# Norlite Corporation

SUBJECT: Fugitive Dust Plan Addendum - Comment Resolution

SUBJECT: Norlite Response to NYSDEC Comments on FDP Addendum  
SCI-TECH Project No. 95065

## 8.0 SCHEDULE FOR IMPLEMENTATION

18 Fig. 8-2

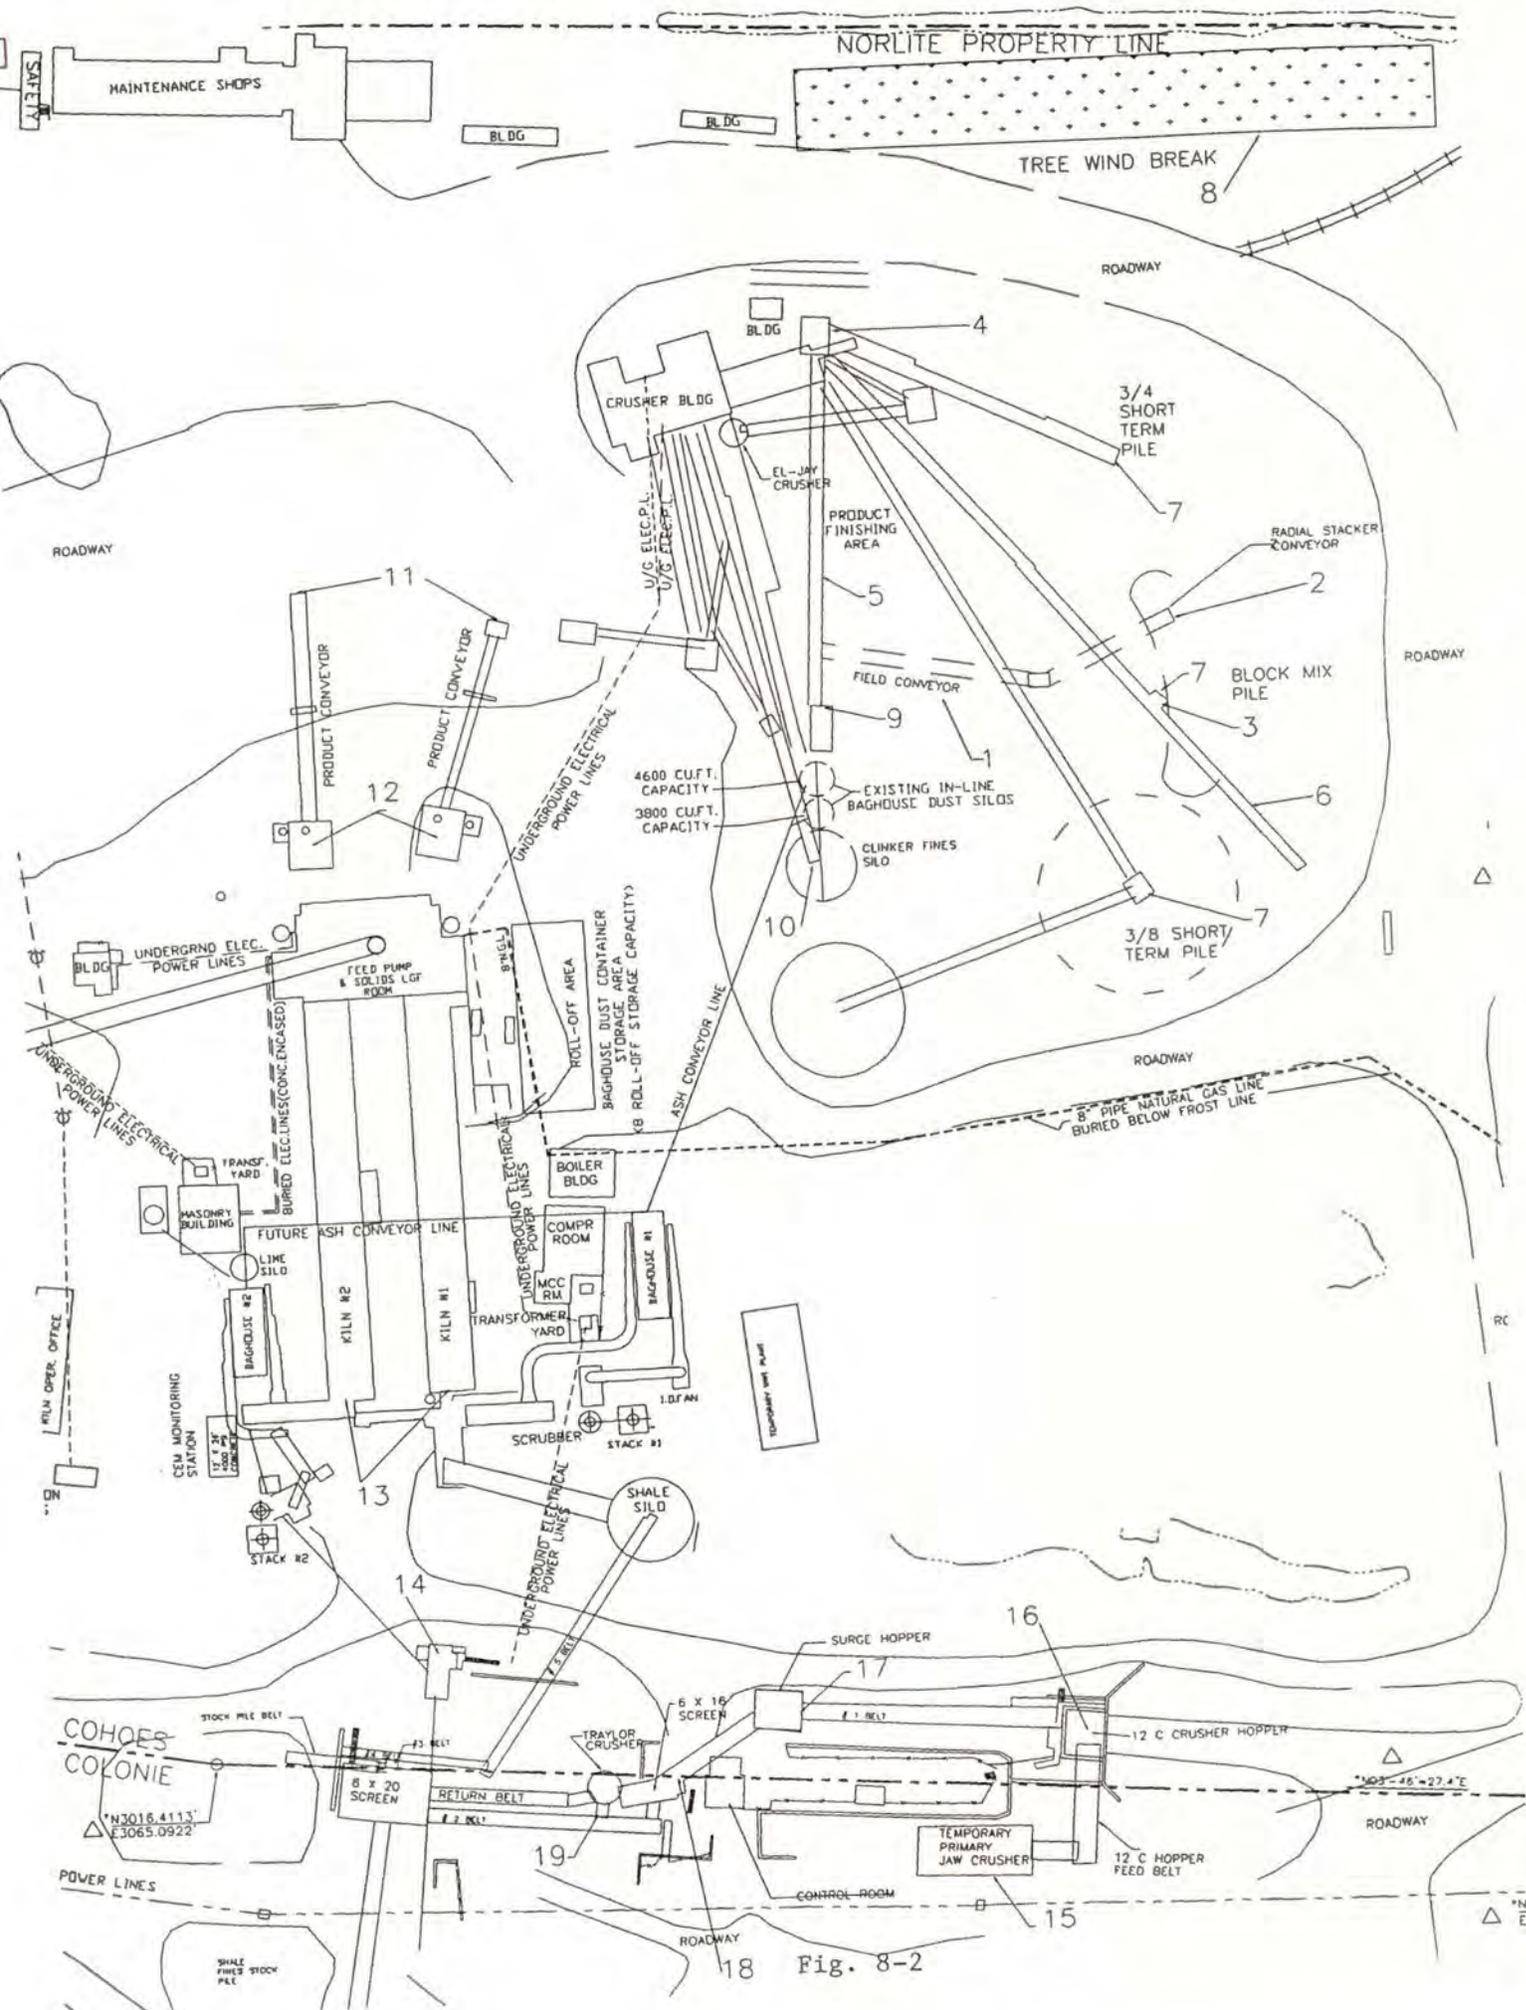
- Windblown Dust Migrating Across Eastern Boundary: Two rows of Douglas Fir trees will be planted along the eastern boundary of the plant (see Fig. 8-2, Item 8). The trees will be placed far enough apart to allow for future growth, and will be staggered to provide a continuous wind break along the boundary. When planted, the trees will be 10 to 12 feet in height with an approximate branch span of 6 feet.

- Finish Mill Short Term Storage Piles: Short term storage piles at the finish mill (Fig. 8-2, Item 7) are currently wetted with Toro or Rainbird type sprinklers as shown in Figures 8-7 and 8-8. These sprinkler systems will continue to be used during non-freezing weather conditions. The sprinkler on the current block mix conveyor belt will be relocated to the new radial stacking conveyor head pulley (Fig. 8-2, Item 2) to ensure that the block mix pile will continue to be sprayed with water.

Figure 8-6

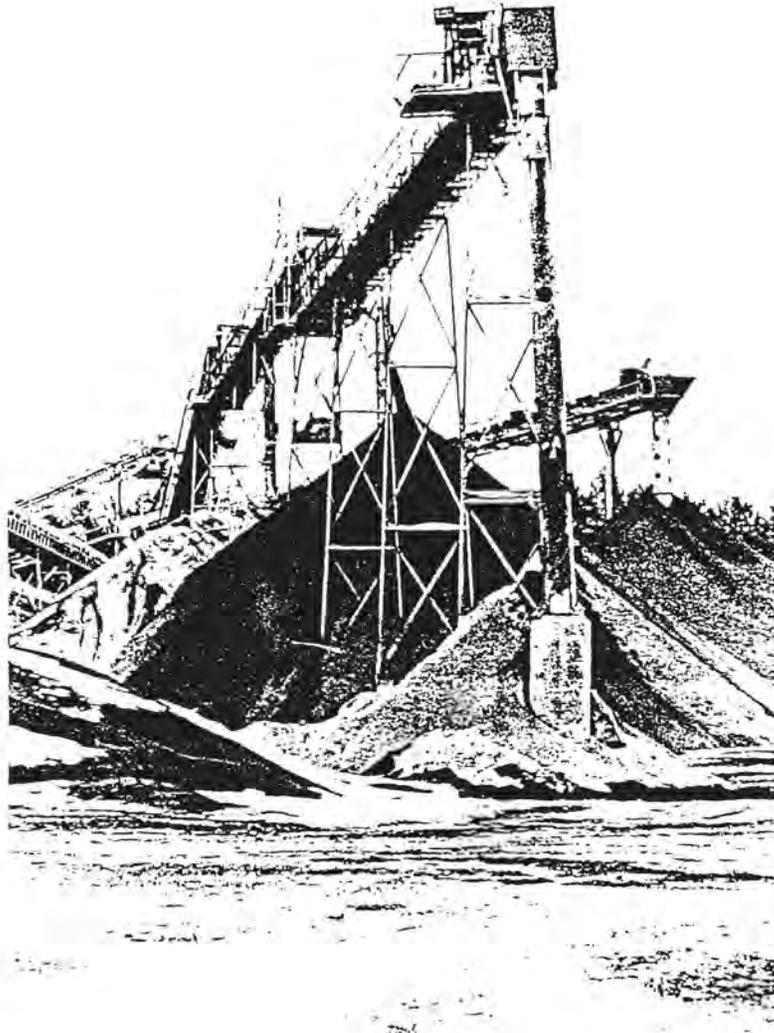
- Stacking Tubes: The stacking tubes for block mix (Fig. 8-6) will be eliminated by installation of the radial stacking conveyor. Side outlets in the 3/4's stacking tube (Fig. 8-7) will be covered with rubber flaps to minimize fugitive dust emissions from this source.

The current block mix conveyor and stacking tubes will be removed after the radial stacking conveyor is installed. The stacking tube plugs frequently and causes excessive drop heights. The radial stacker will raise and lower to control the drop height of block mix.

Figure 8-9

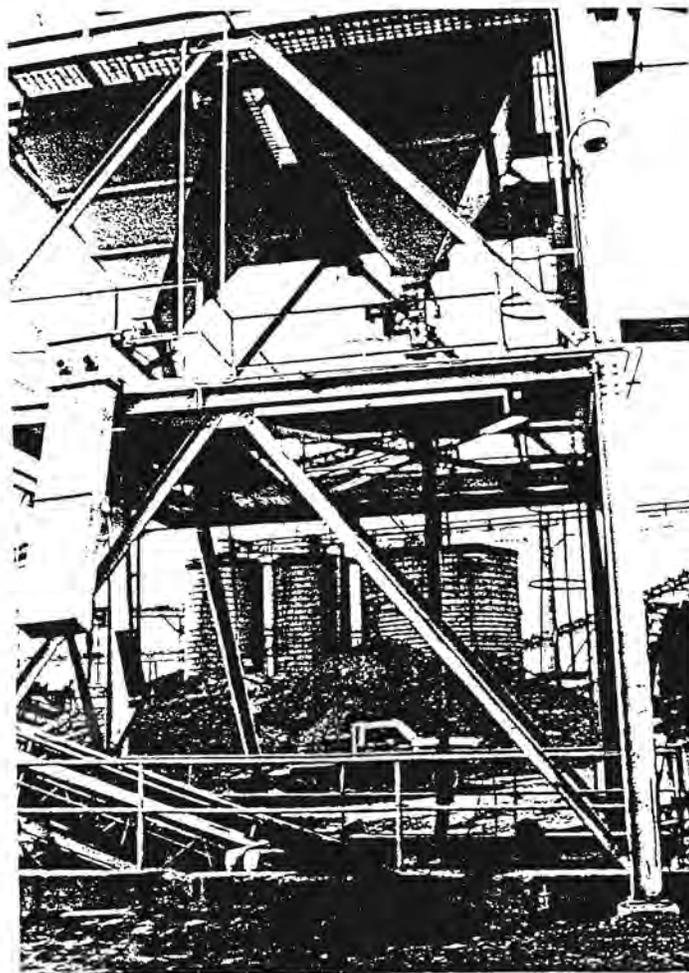
- Clinker Dust to Clinker Belt: The dust collected in the clinker cooler Barron system (Fig. 8-9) that is currently transferred to the clinker pile via the clinker conveyor belt, will be transferred to an enclosed hopper. The dust will be wetted in the hopper and transferred to the clinker pile as a wet slurry. Figure 8-10 shows the skid mounted dust collector hopper.

Excess air from the clinker cooler passes through the Barron Fan system (shown). Dust is removed from the air and is transferred from the hopper on the upper right to the clinker belt via a square chute. Dust will be transferred to a hopper and later mixed into the product piles.

Figure 8-12

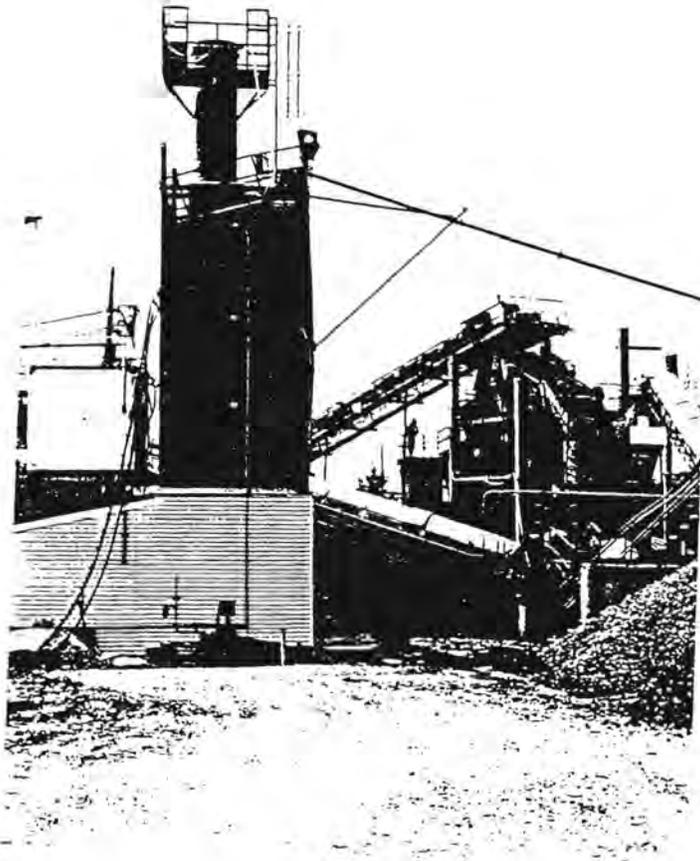
- Improved Soda Ash Silo Baghouse: The original Soda Ash Silo baghouse (Fig. 8-2, Item 14) was removed and replaced with a modern pulse-jet bin vent (Fig. 8-12) in June 1995.
- Railcar and Truck Loading: Norlite will prepare a standard operating procedure (SOP) to cover loading of trucks and railcars with block mix near the eastern plant boundary. Since the fundamental problem is the transport of wind borne dust across the eastern plant boundary, Norlite will install local wind monitoring stations near the loading areas. The SOP will be developed by observing and experimenting with loading operations over the course of a representative period. The goal will be to identify a set of acceptable practices and conditions, including wind speed and direction, during which block mix can be loaded without generating fugitive dusts which migrate across the eastern plant boundary.

The Soda Ash Silo bin vent was replaced with a much larger Aeropulse bin vent (shown)

Fig. 8-16

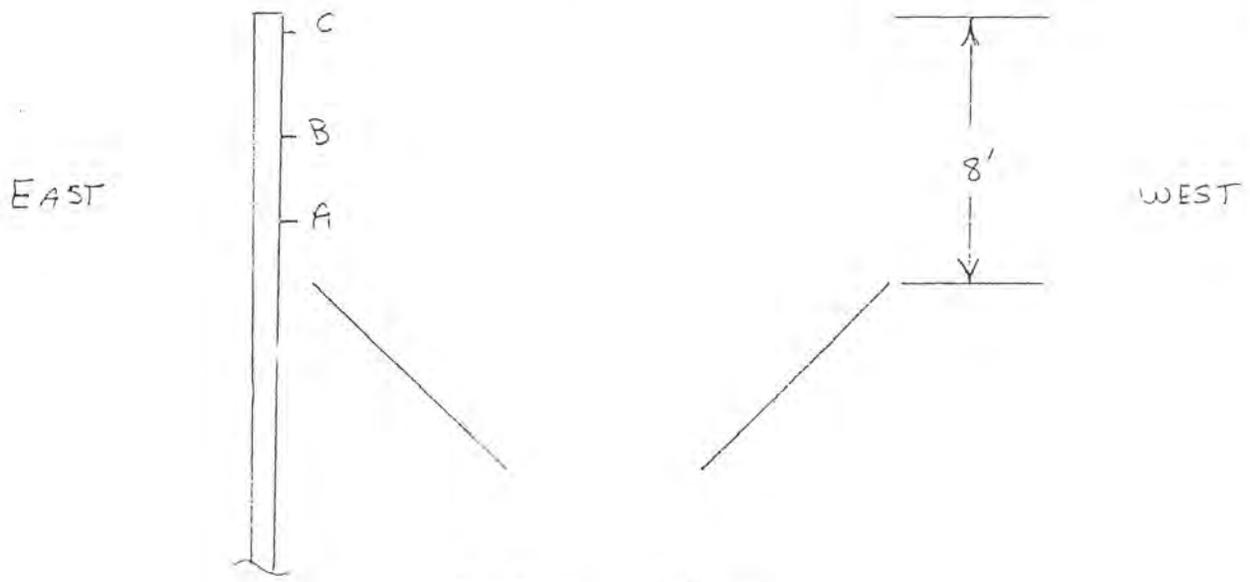
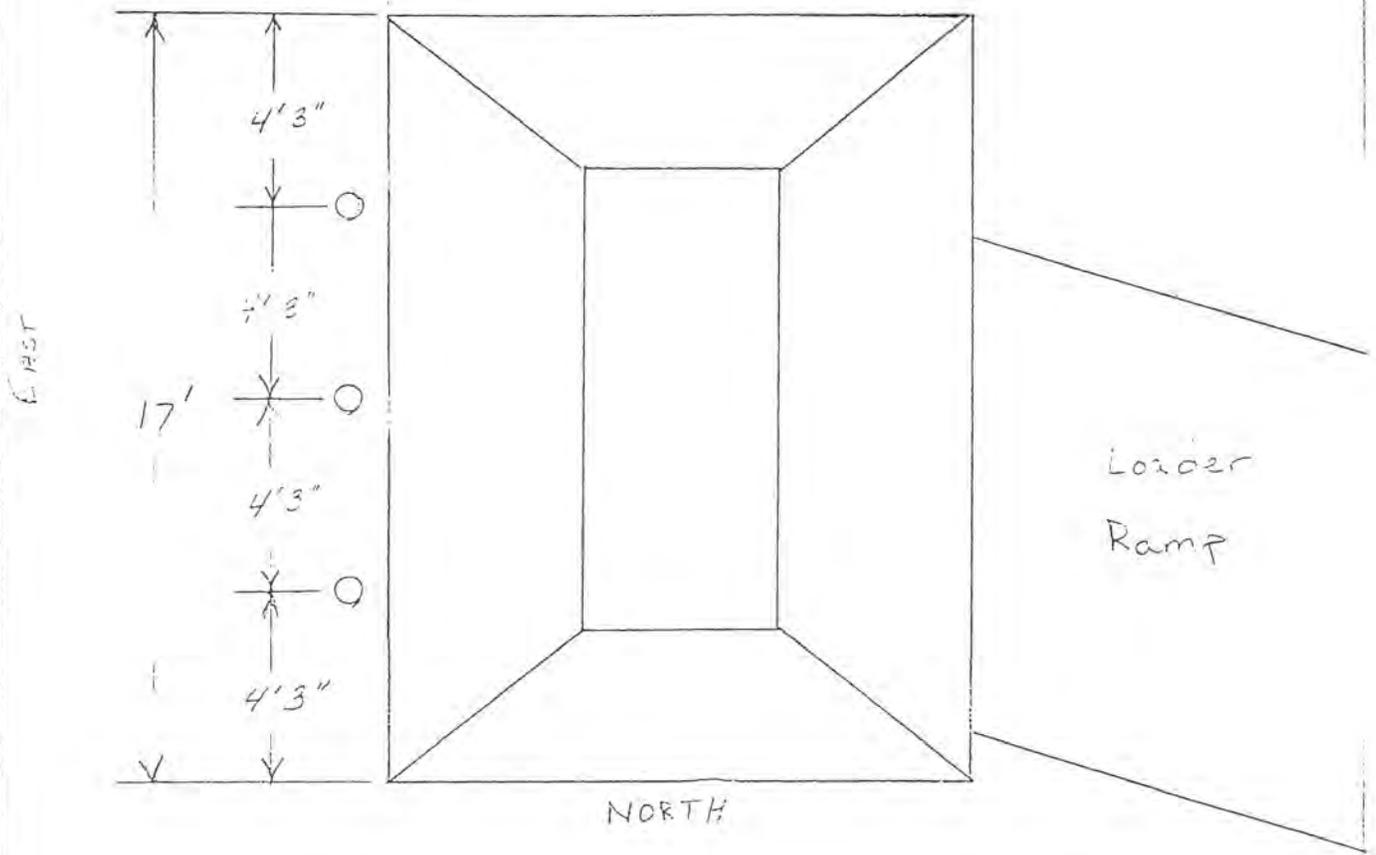
The primary jaw crusher (Fig. 8-2, Item 15; Fig. 8-17) will have 3 spray headers (with 3 nozzles each) located at the loading hopper. Figure 8-16 shows plan and side views of the spray headers and the hopper. Figure 8-18 is a detailed sketch of the spray header. All nine nozzles will be in continuous operation while stone is being crushed.

9 Spray Nozzles  
Continuous operation during crushing.

Figure 8-17  
Primary Jaw Crusher and Ramp (foreground). Facing East.

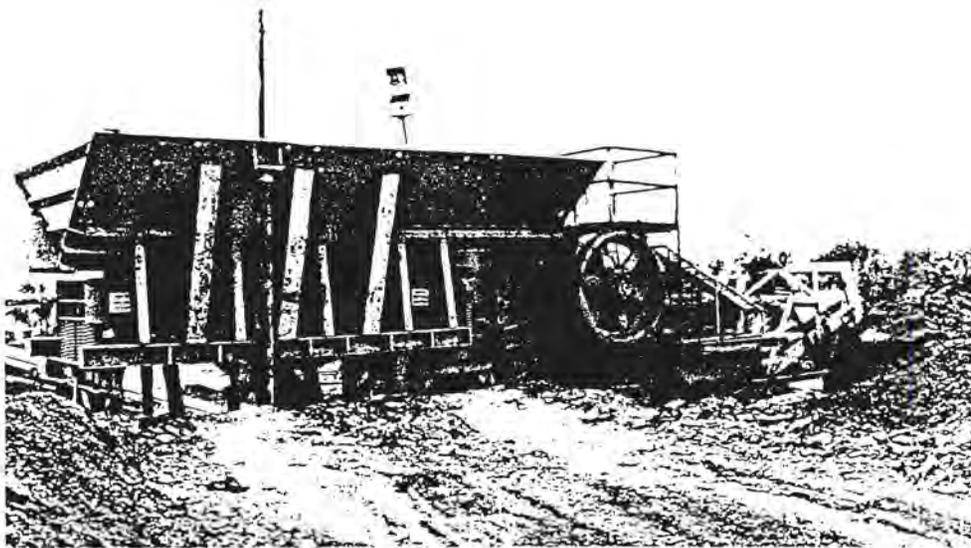
Shale (Shot Rock) is dumped into the portable jaw crusher hopper by a front end loader. Crushed shale exits the crusher on the conveyor at the right. Spray bars will be installed on the east side of the crusher hopper (fig. 8-19) and at the head pulley of the discharge conveyor (fig 8-19).

Fig. 8-19

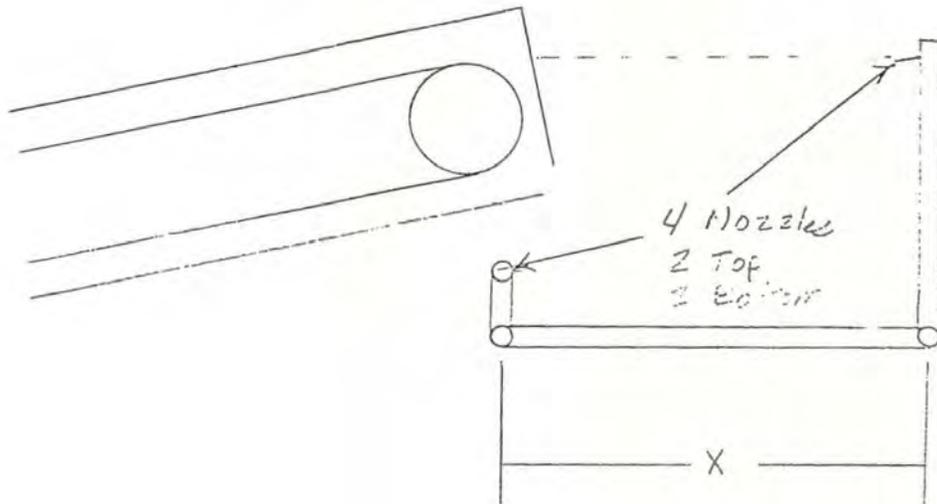
Figure 8-19 provides details of the spray manifold on the primary jaw crusher (Fig. 8-2, Item 15) conveyor discharge. This spray system has four nozzles which operate continuously during stone crushing operations.

$$y = \frac{1}{3} X$$

36" wide belt  
 $X \cong 40"$

$$y = 13.33"$$

$$y = 1' 1\frac{1}{4}"$$

Spacing between nozzles = 13 $\frac{1}{4}$ "

Continuous Operation During Crushing

Figure 8-21  
12 C Crusher Hopper Facing North-West.

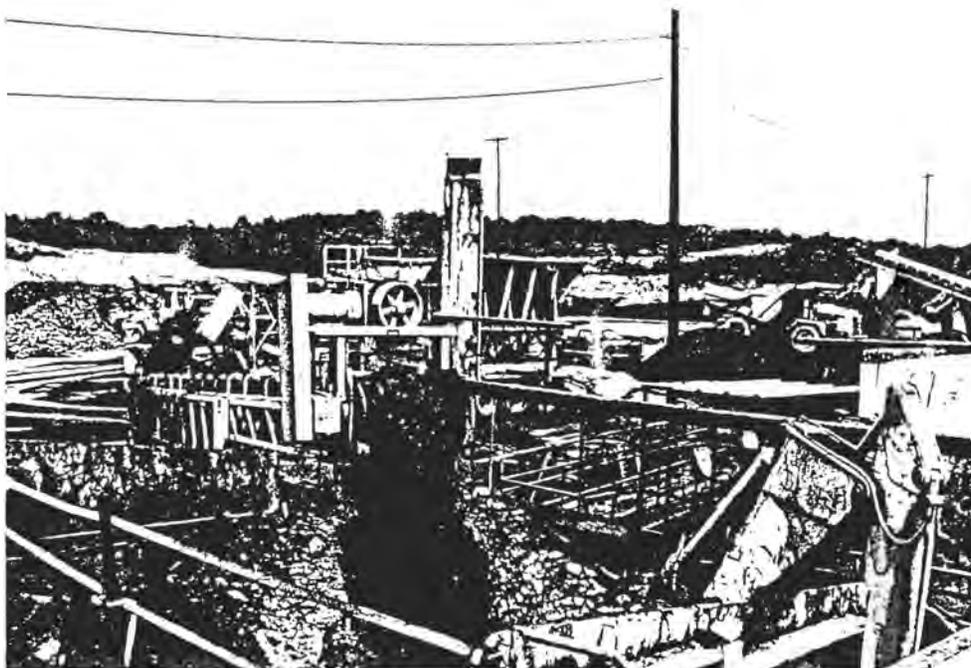
Stone is transferred to the 12 C hopper (Fig. 8-2, Item 16; Fig 8-21) from the primary jaw crusher via a conveyor belt. Dust is suppressed in the 12 C hopper via two spray bars (Fig. 8-20). One spray bar is centered over the top of the hopper with the spray directed downward. The second spray bar has two nozzles, one of which is directed at the stone being discharged from the conveyor belt, while the second is pointed up at a 30° angle towards the center of the hopper. These sprays operate continuously while stone is being discharged from the transfer conveyor into the 12 C hopper.

Shale is conveyed to the 12 C Crusher Hopper from the primary jaw crusher via a transfer conveyor. One spray bar will be installed over the center of the hopper to suppress dust. Another spray bar will be installed closer to the head pulley of the transfer conveyor (fig. 8-20)

Figure 8-25  
Finish Plant Fines Silo and Fines Chute

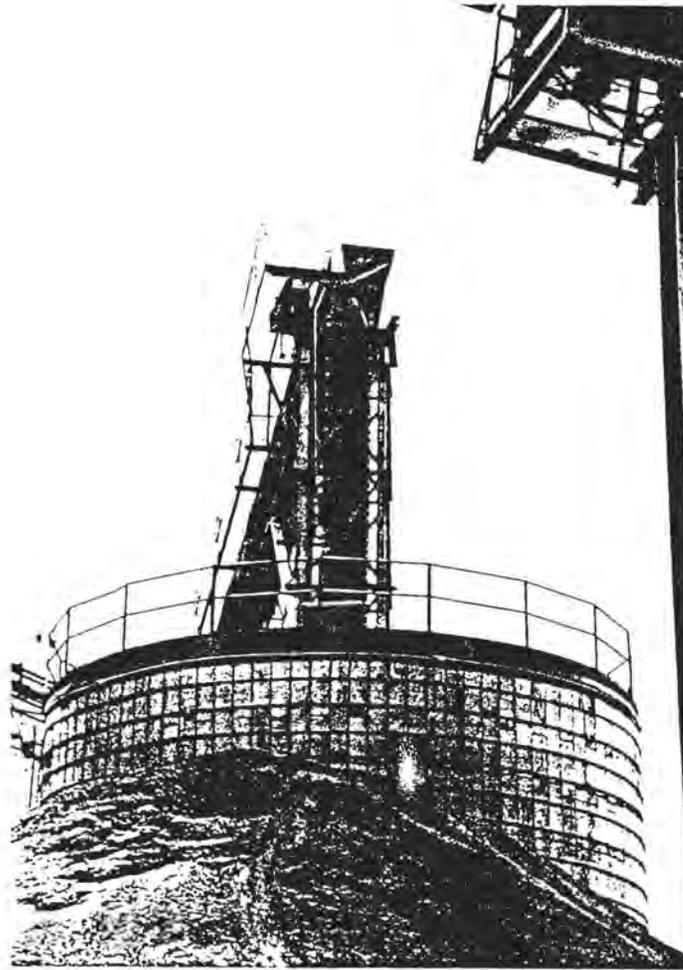
A second source of fugitive dust was a defective drop chute on top of the silo (Fig 8-2, Item 10). The chute had several wear holes caused by abrasive scouring. During May, the chute was redesigned and repaired by replacing eroded material with an abrasion resistant metal. The repaired areas were fabricated as bolted sections which can be readily replaced for easier maintenance (Fig 8-25). Regular inspection will ensure that the chute is properly maintained.

The West face of the fines silo chute (shown) has been redesigned with easily changed, wear resistant plates (also shown).
